Response to Agency Preliminary Comments on Labadie Energy Center §316(a) Draft Demonstration Study Report

MDNR/MDC Comments

Figure 1. Seasonal fraction of the fish community comprised of heat intolerant species as numbers (left) and biomass (right) in the vicinity of the LEC in 2017-2018.

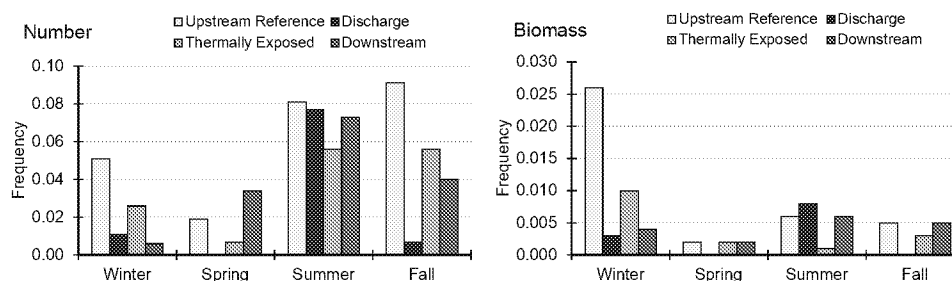
- According to the text, there were no heat intolerant species counted in the discharge and thermally exposed areas, but Figure 5-19 appears to show the opposite.

- In addition to this, please graph these by season as Section 6.3.3 indicates certain intolerant species will be completely absent if the river exceeds certain temperatures. Seasonal density graphs were completed for the macroinvertebrate community in Figure 5-24.

- c. Graphs in Section 5 were selected to illustrate patterns in the data, without overwhelming the reader with more graphics than can be assimilated. The seasonal aspect of the prevalence of heat tolerant and intolerant species was incorporated into the analysis. The data for tolerant and intolerant species, segregated by gear and season, are provided in Appendix B Tables B-14 through B-17. The standardized differences between Upstream and either Thermally Exposed or Downstream zones, based on each of these combinations for fraction intolerant species are provided in Appendix B Tables B-18 through B-21. All of the standardized differences for each combination of gear x season, for both numerical abundance and biomass (without preference) were included in the overall weight of evidence, along with differences based on other metrics, in Figure 5-22.

To satisfy the request, figures similar to Figure 1 are provided in the Supplement (Section 3) to demonstrate the seasonal component of heat-intolerant species as it relates to numerical abundance and biomass.

Figure 2. Maximum temperature at the edge of the 25% Mixing Zone vs. TDP

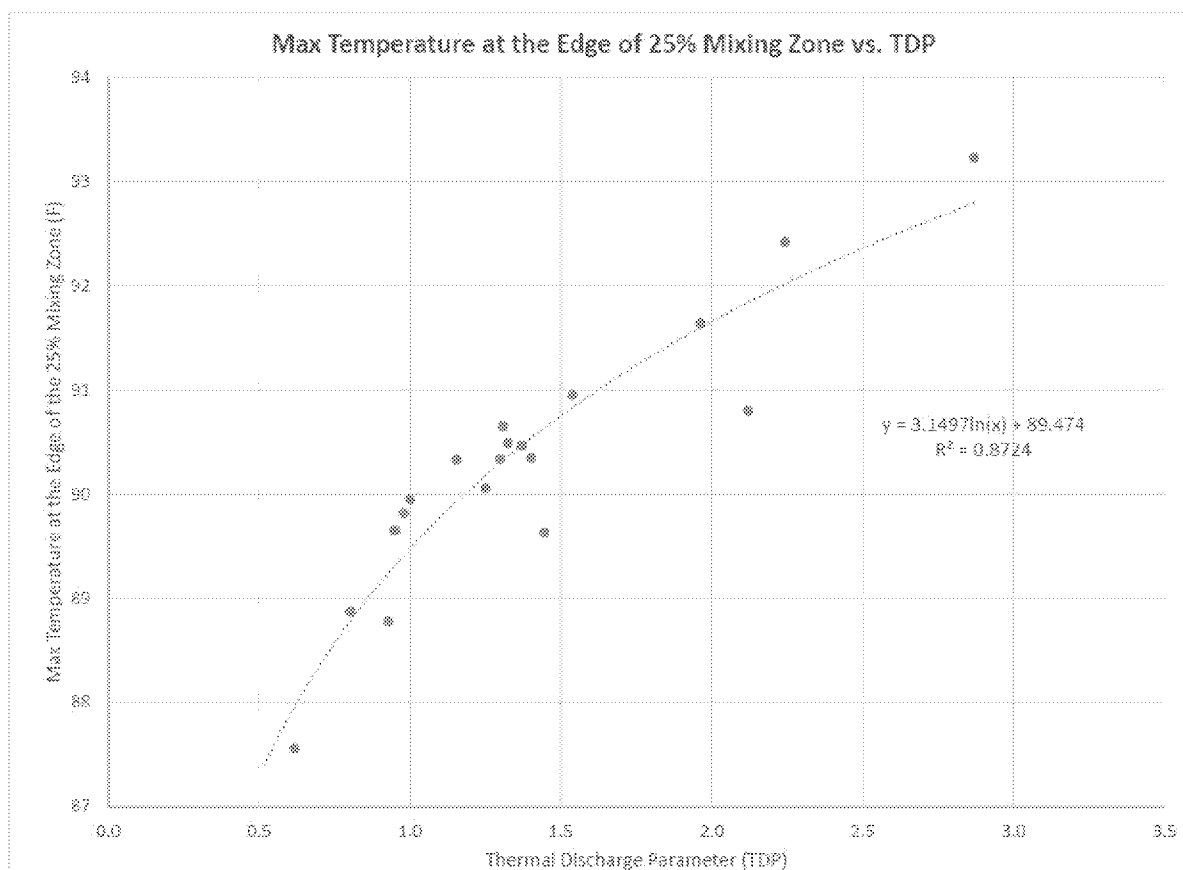
7. The Ameren variance request appears to be based on the logic of the Mississippi River criteria and this seems appropriate. The questions/comments below are based on that approach. While variable with river temperature, what is the more elevated temperature (>5°F) at the edge of the 25% mixing zone when the RMZ is expanded to 40% of the river? Does this equate to an additional 3°F increase above 90°F? Is the 40% value based on a calculated zone of passage or a maximum temperature at the higher RMZ? Ameren's variance request should define the increase in temperature above 90°F when the larger RMZ is allowed.

RESPONSE: On days when the 316(a) variance is invoked, the 90°F and delta T less than 5°F requirements will always be met within a 40% mixing zone, but on those days the temperature will be either be (a) above 90°F or (b) more than 5°F above background in a 25% mixing zone. Hence the need for the 316(a) variance.

In response to this comment, we analyzed the model output from a subset of the previously conducted simulations that were run to develop the effluent limitation equations in Tables A-1 and A-2 of the NPDES permit. For each simulation, we determined the location along the river where the maximum temperature occurs after mixing with only 25% of the river flow. At all other locations, the temperature would of course be less than the maximum. The simulations analyzed represent a range of river and discharge temperatures and flows.

The results for the maximum temperature at the edge of the 25% mixing zone for each simulation are provided in the attached Figure. As expected, the Figure demonstrates that the maximum temperature is a function of the TDP. (Recall that the TDP is a composite measure of the combined effect of river and discharge flows and temperatures.) As can be seen, the maximum temperature at the edge of the 25% mixing zone will exceed 90°F at TDP values above 1, again as expected and as we have previously demonstrated. Nonetheless, the Figure further demonstrates that maximum temperature at the edge of the 25% mixing zone will always be below 94°F even for a simulation with TDP as high as 2.87. Analysis of the historical database (January 2002 – December 2018) indicates that TDP never would have exceeded 2.65. So, even when the variance may be invoked allowing temperature in the river to exceed 90°F in up to 40% of the river, the temperature will still be below 94°F in 75% of the river (i.e., be above 94°F in only 25% or less of the river), and will be below 90°F in 60% of the river (i.e., above 90°F in only 40% or less of the river). Furthermore, these maximum percentages will occur for only a small segment of the river and will be less at all other locations in the river.

For most instances during which the variance may be invoked the maximum temperature at the edge of the 25% mixing zone will only be one or two degrees above 90°F. For example, as shown in Figure 2, for a TDP value of 2.3, the maximum temperature at the edge of the 25% mixing zone will still only be about 92°F. And, TDP values at or above 2.3 would be extremely rare. The historical record shows that such has occurred on only 4 days out of 6018 days (less than 0.1% of the time). So, on days when the variance will be invoked, the maximum river temperature at the edge of the 25% mixing zone will typically be around one and almost always less than two degrees above 90°F, but never above 94°F.
